87-95 BROOKSIDE LANE

APPLICATION FOR PERMIT FOR HEATING, COOKING OR POWER EQUIPMENT

(RAA) APPLICATION FOR PERMIT

APPLICATION FOR AMENDMENT TO PERMIT

revised 8/26/97  
Trellis

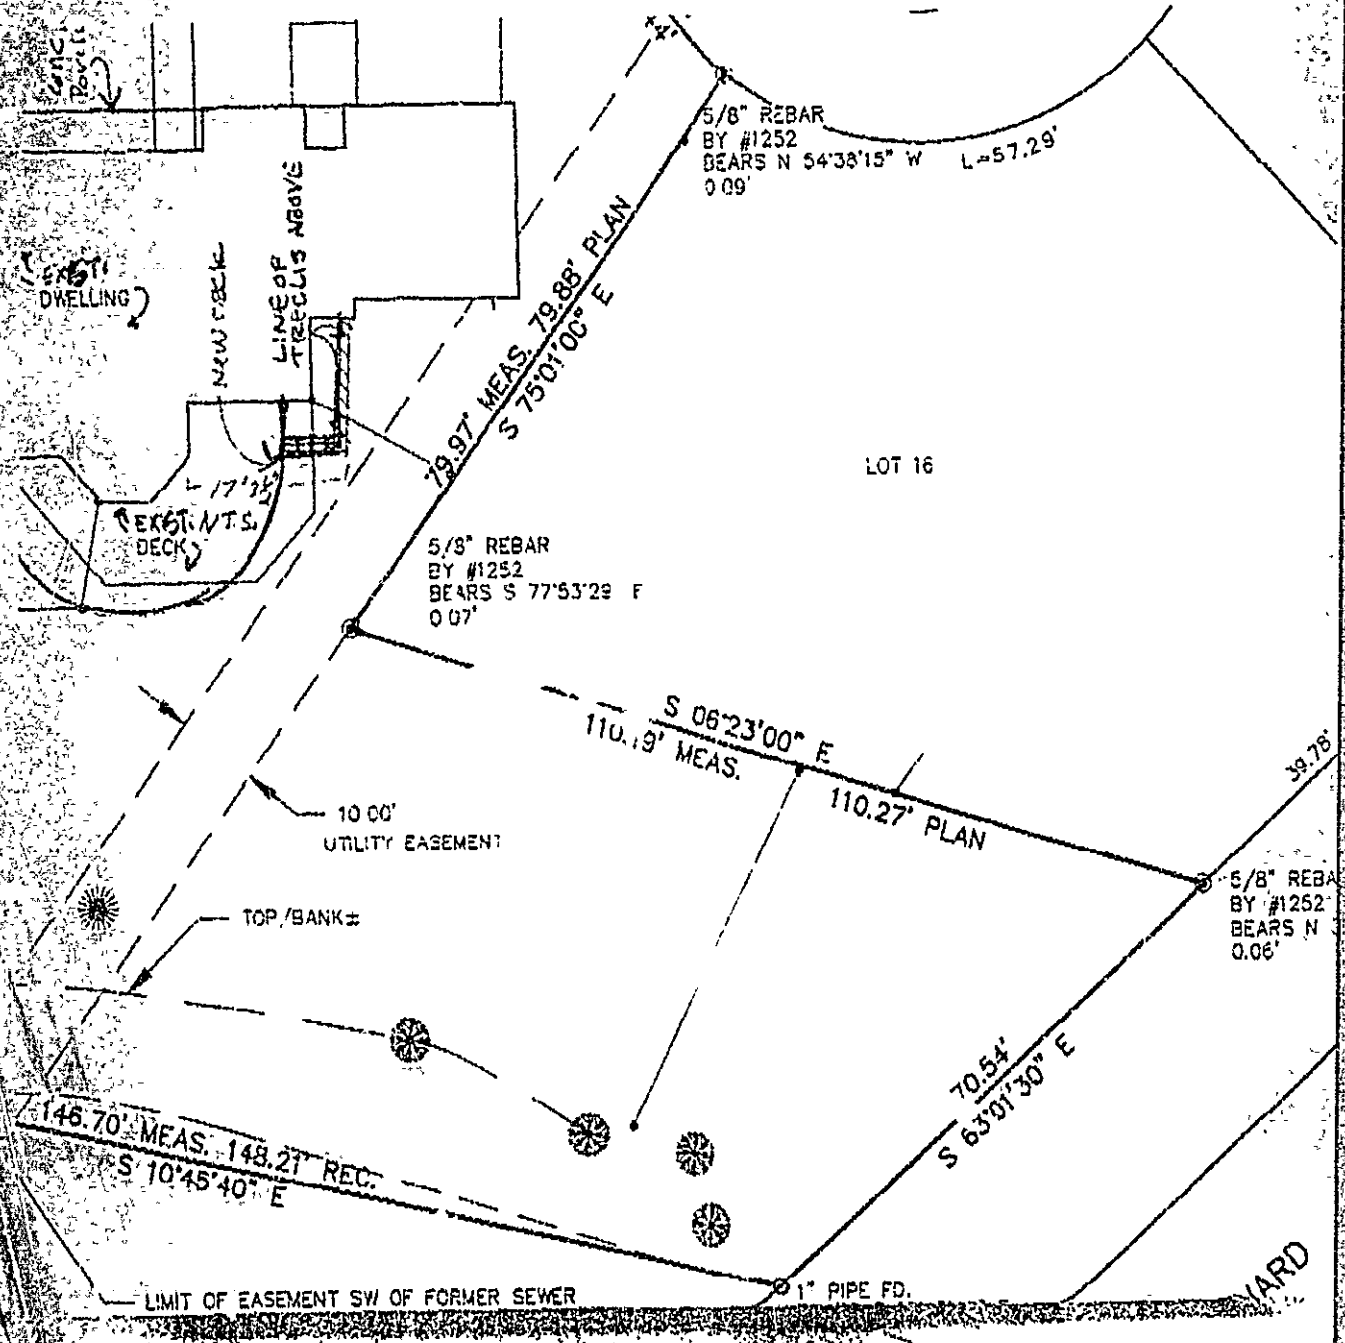
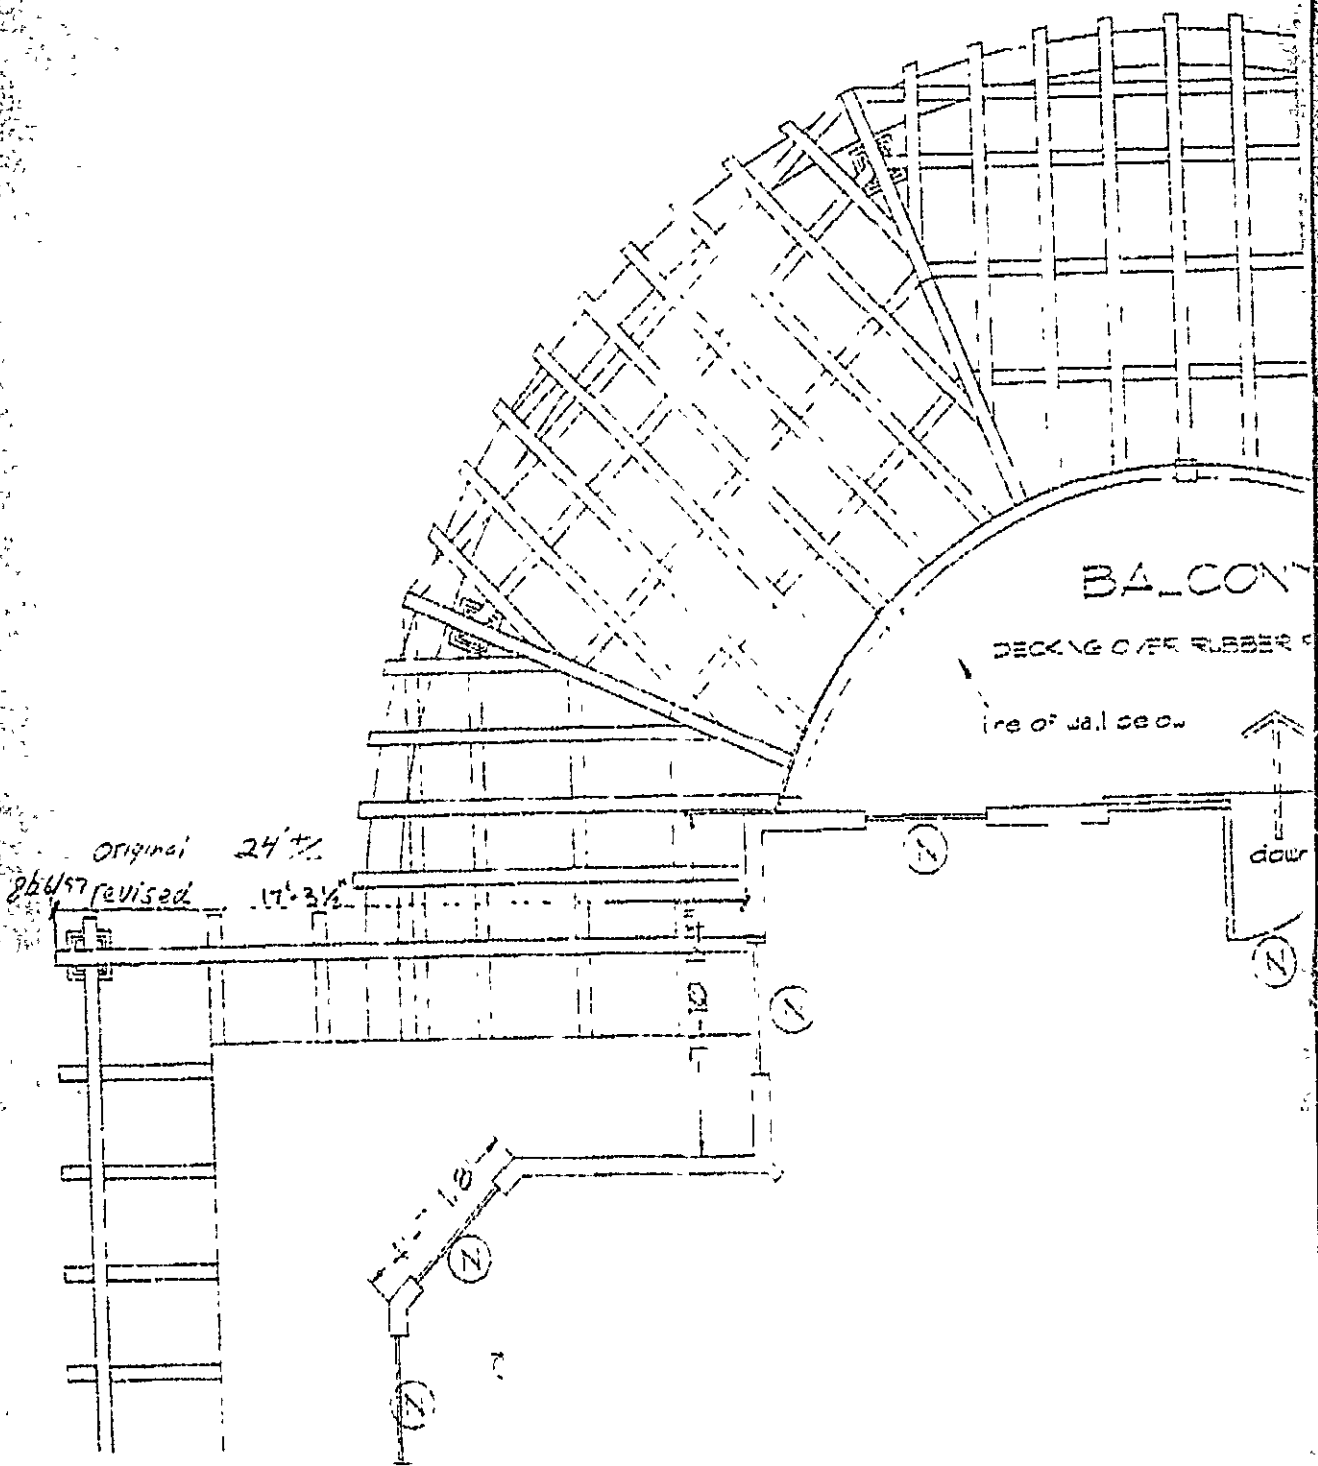
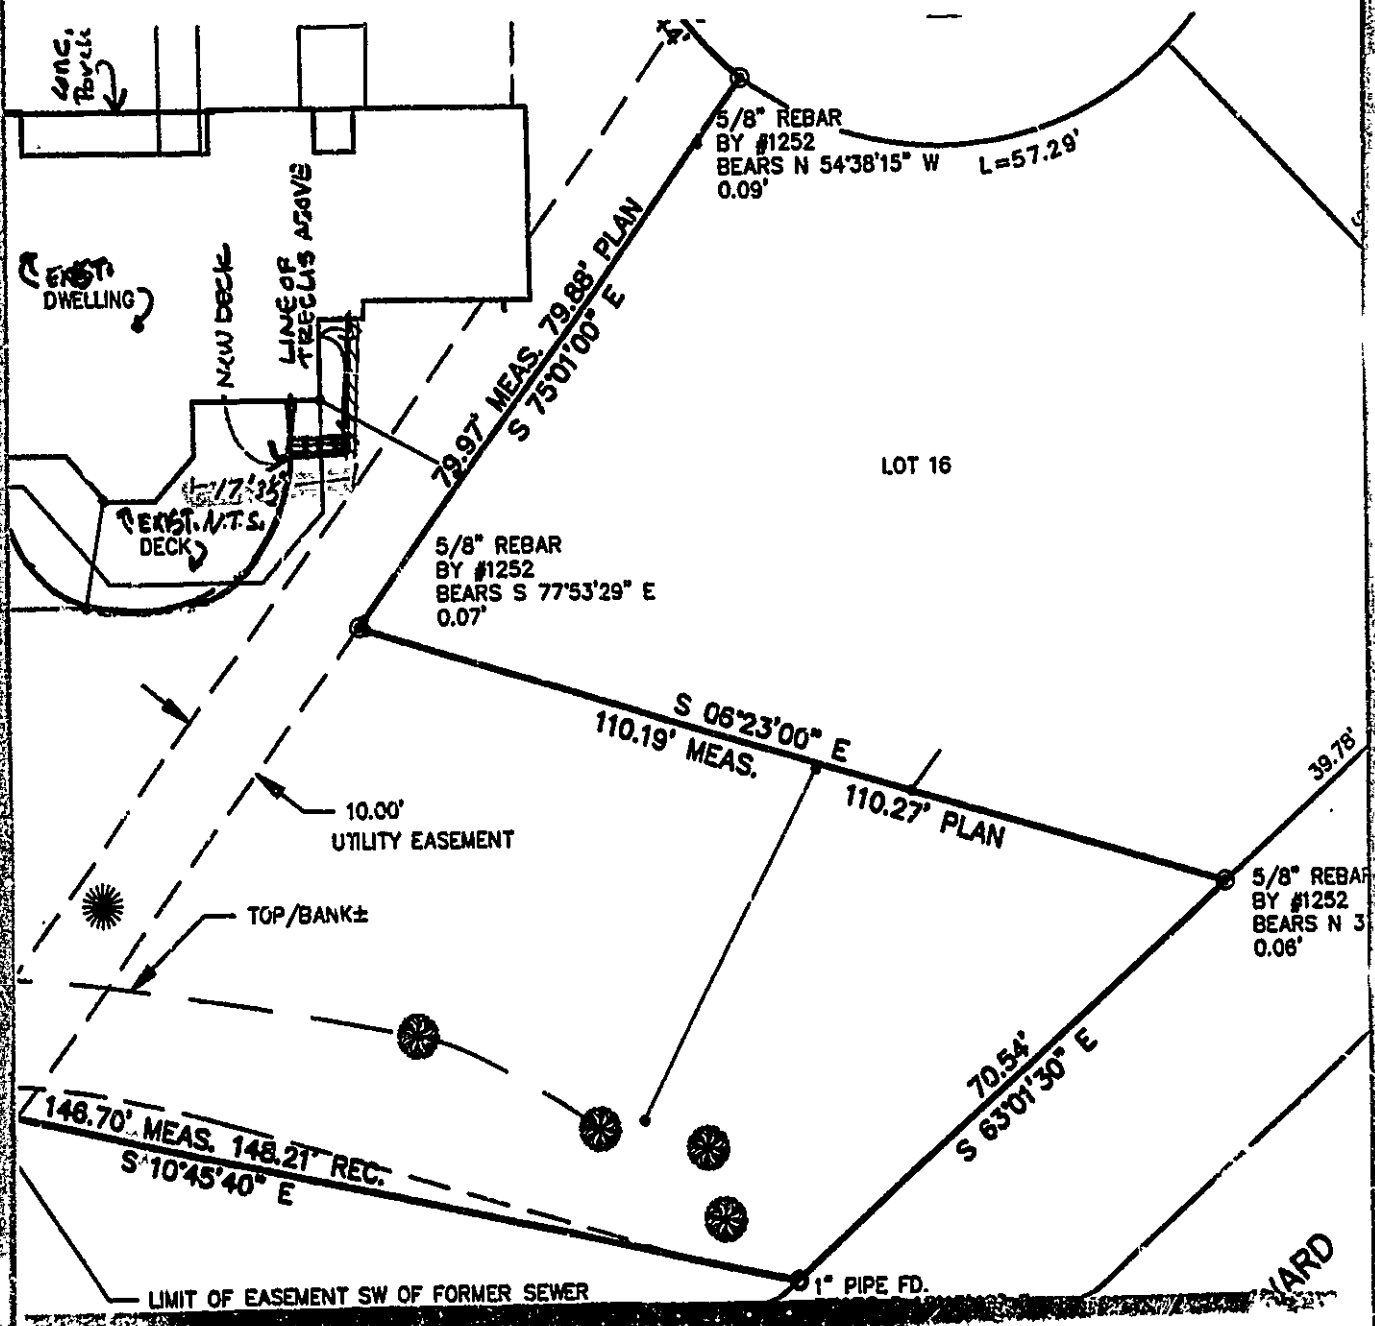
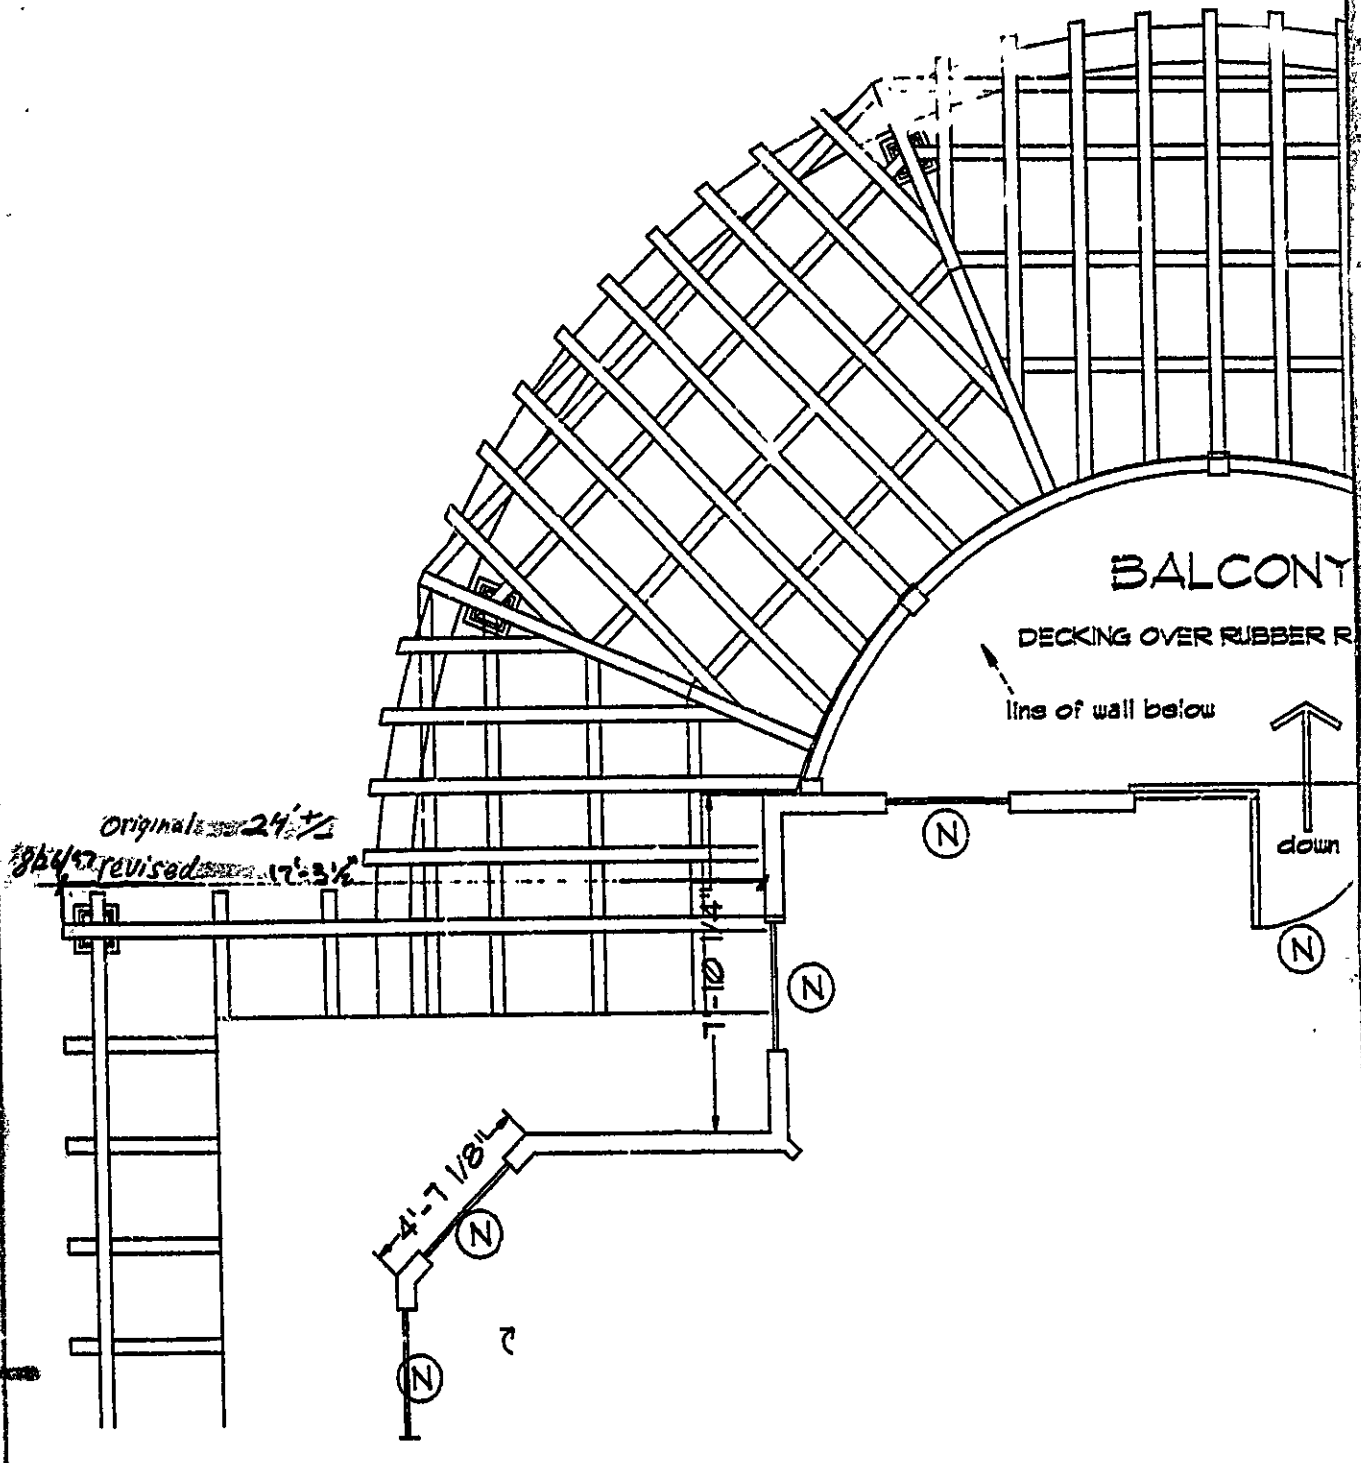
Attached are two revised plans indicating revisions to the trellis dimensions from the originally submitted 24 feet. The dimension is now revised to 17' feet 3-1/2 inches.

The revisions to the original plan are in respect to Condition number 9 on the building permit regarding the utility easement. With the revisions, the trellis corner will be located approximately 14 feet from the property line and outside the easement.
